TO : All Bidders  
FROM : George M. Wiens  
PROJECT : CTE Classroom Addition  
Vista Murrieta High School  
1615400.41  
SUBJECT : Addendum 2  
DSA : 04-115755 / 33-H18

Addenda No. 2 – Scope of Work Questions

NTS 1

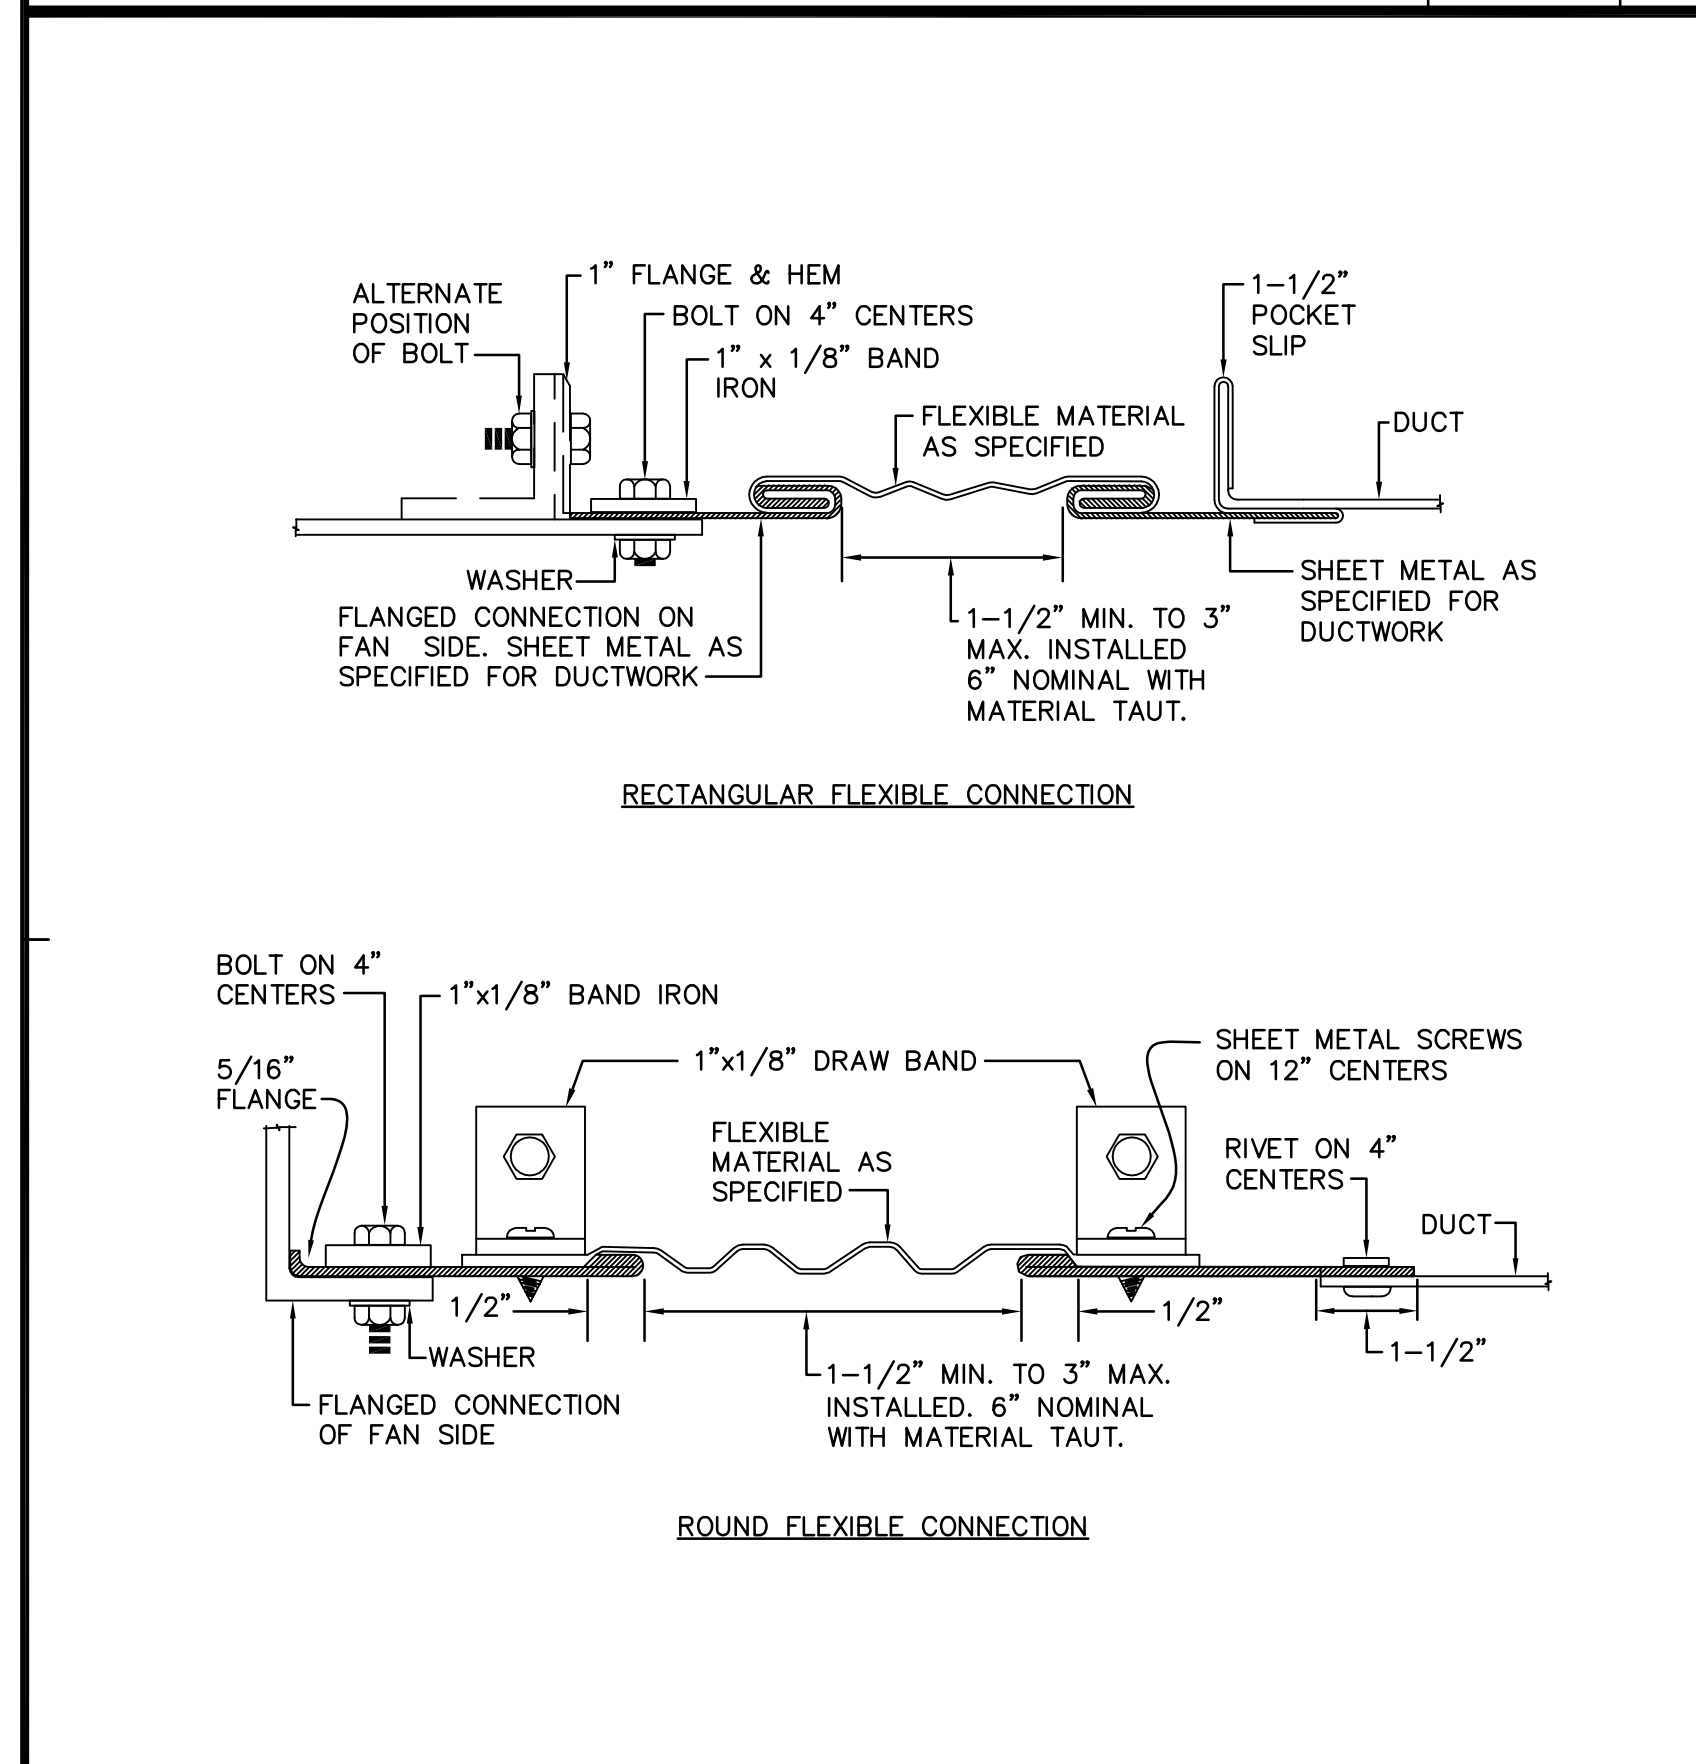
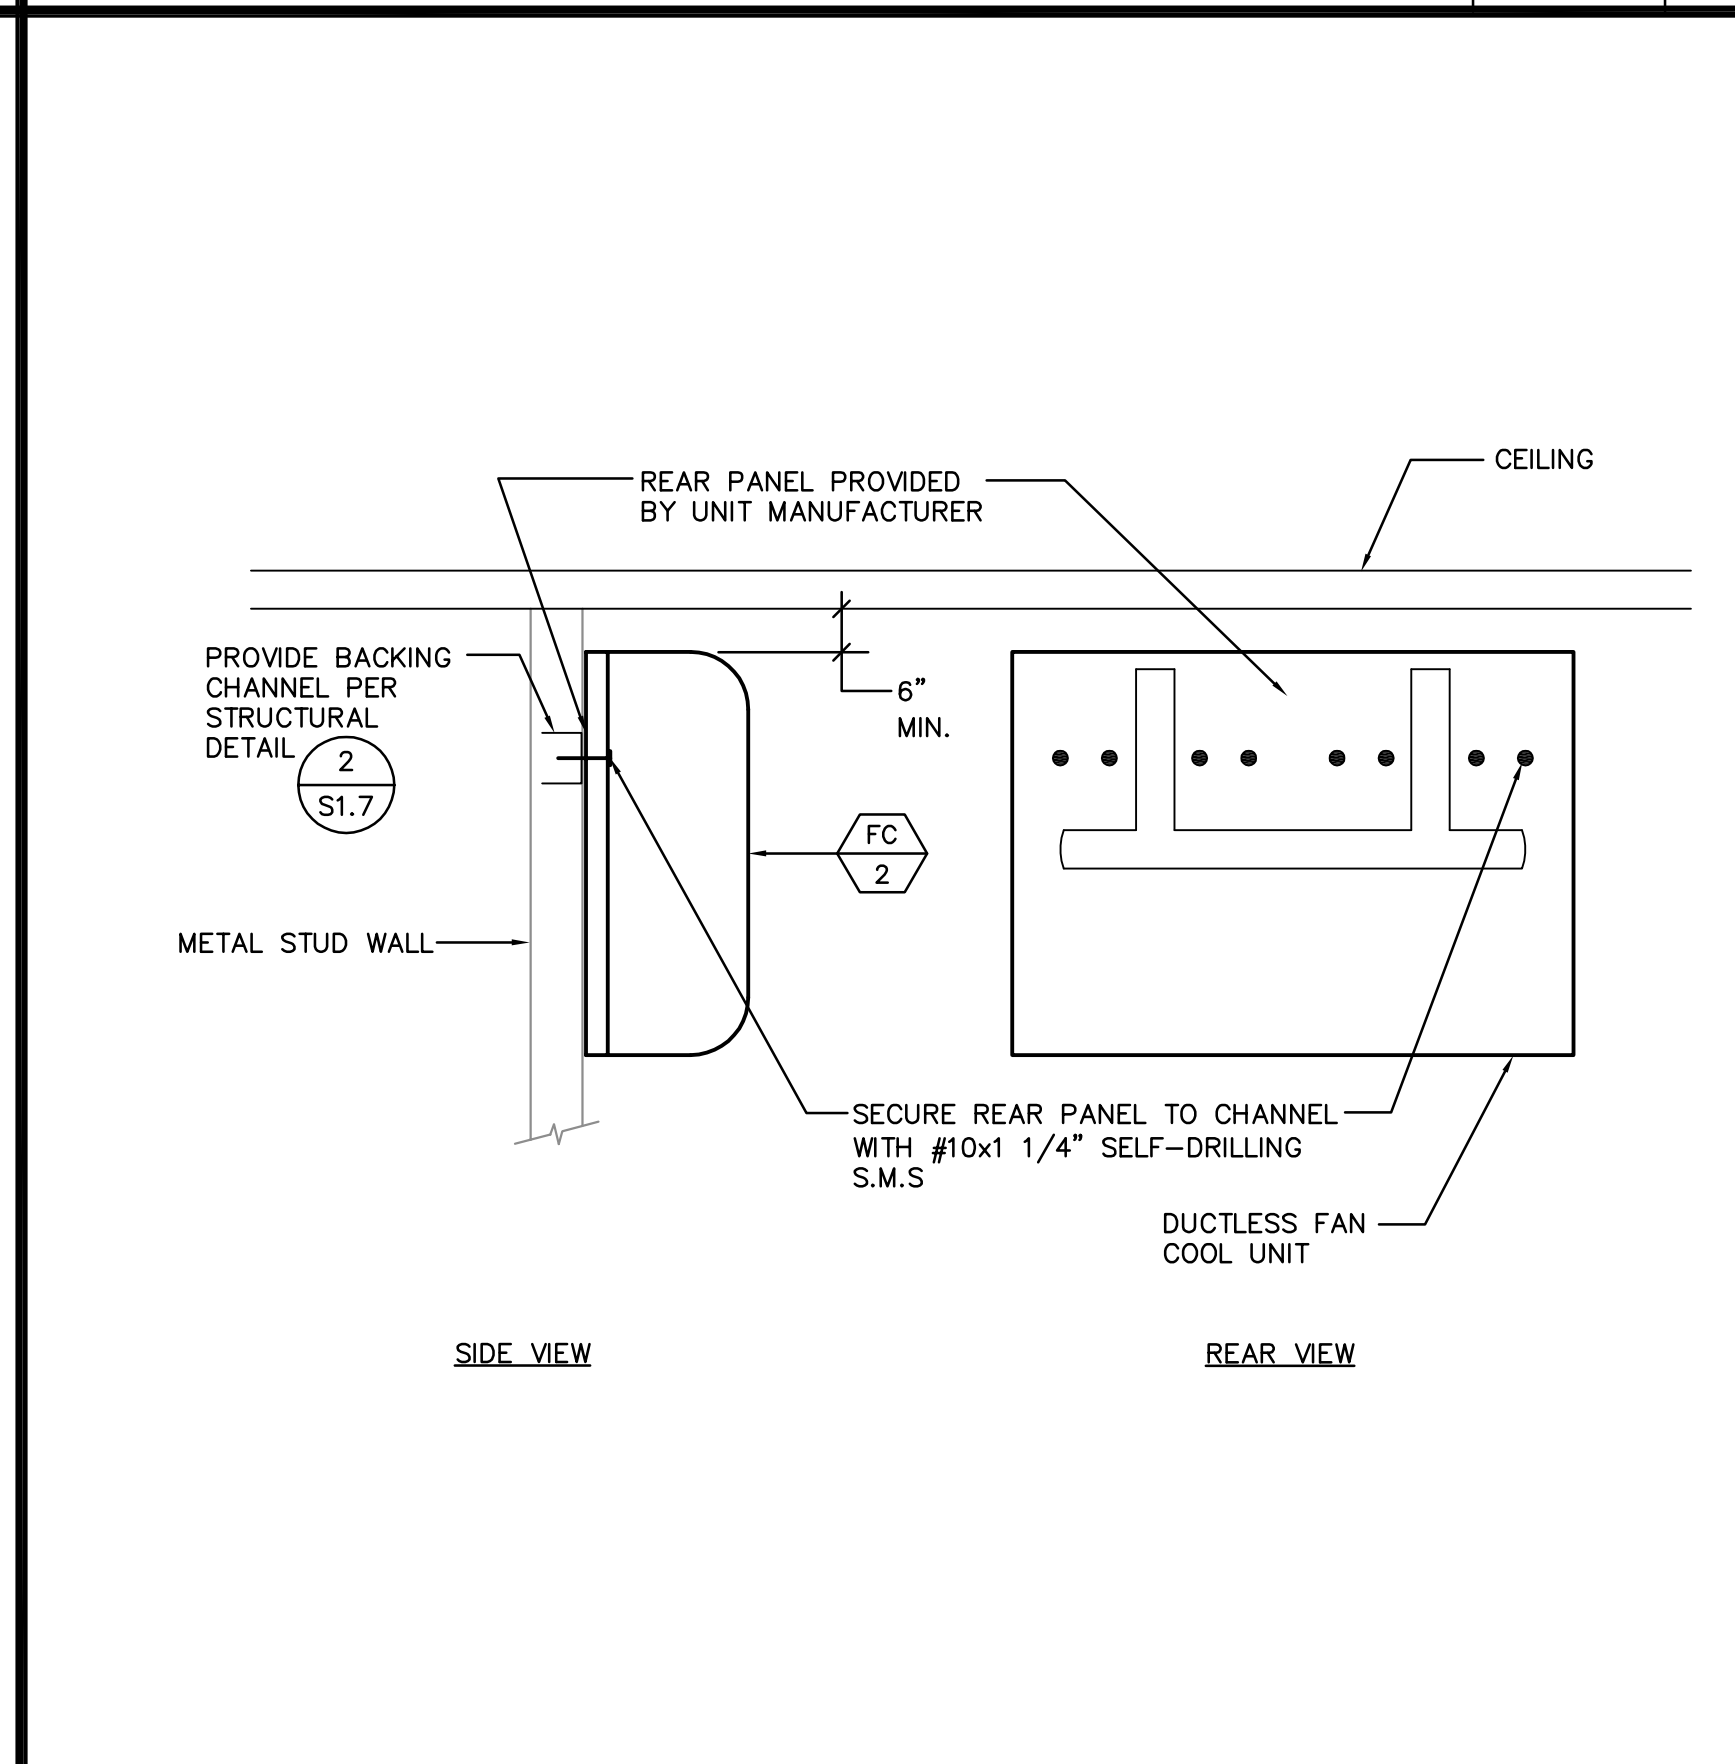
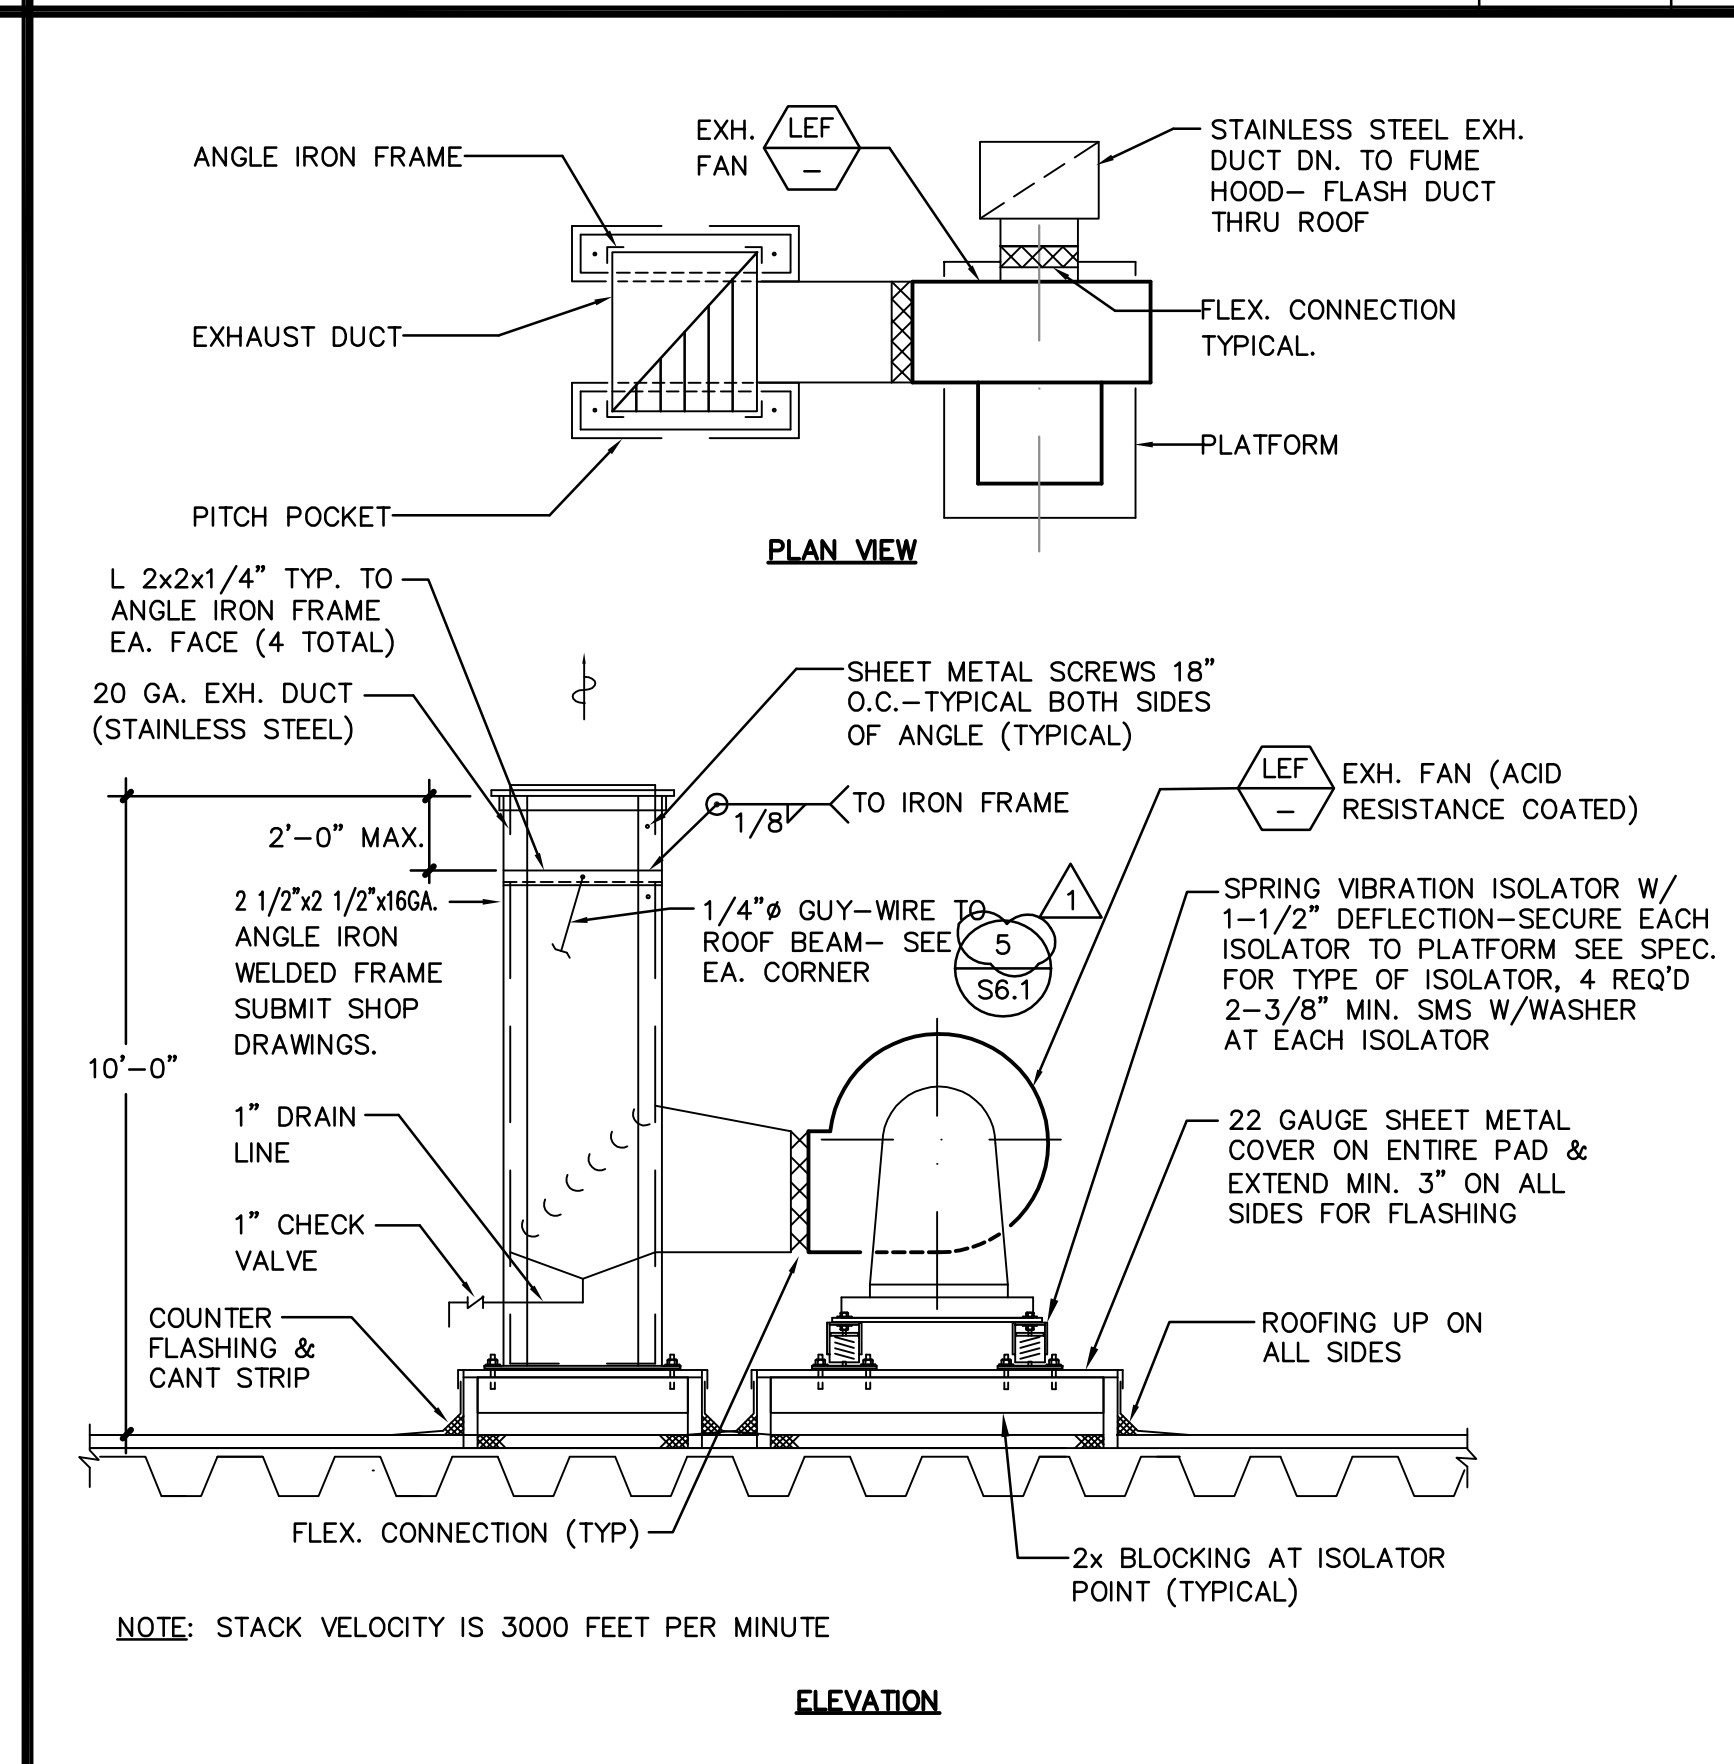
- A. Revise as indicated in the clouded area labeled Delta 2 on the attached M4.2.
